1 Products affected

Product hierarchy no. *			Part no.	SBU	Type / Description	Customer part no.
SBU PG	PGU	Type				
02	005	016	0000001166	See list below	Power Entry Modules w/o Filter	DC11

2 Type of change

Change of material for higher GWFI/GWIT, V-Lock cord retaining feature as standard and the position of type marking.

Old product appearance	New product appearance

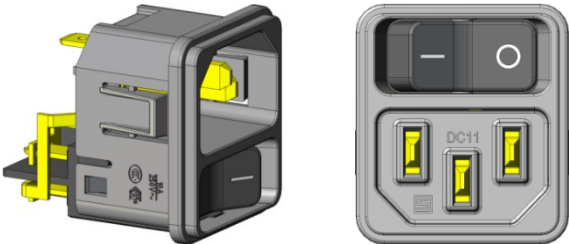
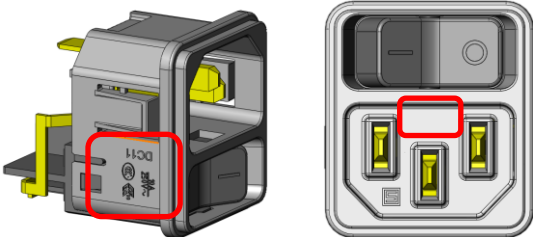
- Material change from PA6 to PA66/6 to pass the enhanced requirements of glow wire test acc. to IEC 60695-2-12 and -13
- V-Lock feature integrated as standard (not an option anymore)
- The Type-marking is new outside of the socket.
